WP ANDERSON CITY PARK

Bid #2023-046

ADDENDUM NUMBER 1

August 16, 2024

MODEL NO. 67567 5" O.D. ARCH TIRE SWING MODEL NO. 67652 ADD-A-BAY ARCH TIRE SWING

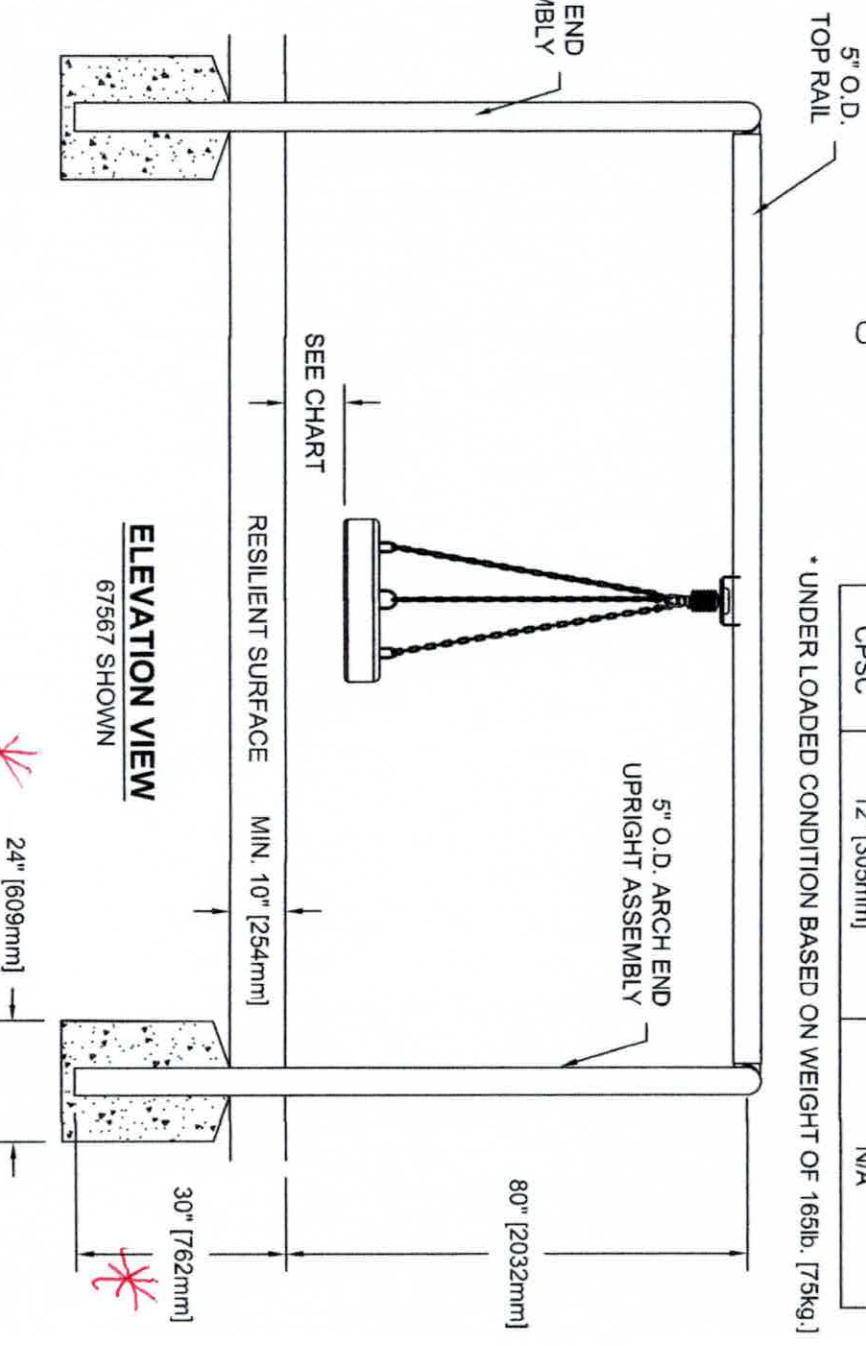
- 1. At the pre-bid meeting held on August 14, 2024, one contractor asked if drainage should be included in the middle area of the oval walkway. The response:
"Contractor to install proper drainage measures as directed by the owner and Landscape Architect. Drainage improvements as part of this project to include: one (1) 24" HDPE Yard Inlet/Basin and 100 linear feet of 8" corrugated HDPE dual wall drainage pipe."**
- 2. At the pre-bid meeting held on August 14, 2024, one contractor asked if there was a technical specification for the swing set re-installation. The response is "yes." Attached to this sheet are the one-page technical specifications.**
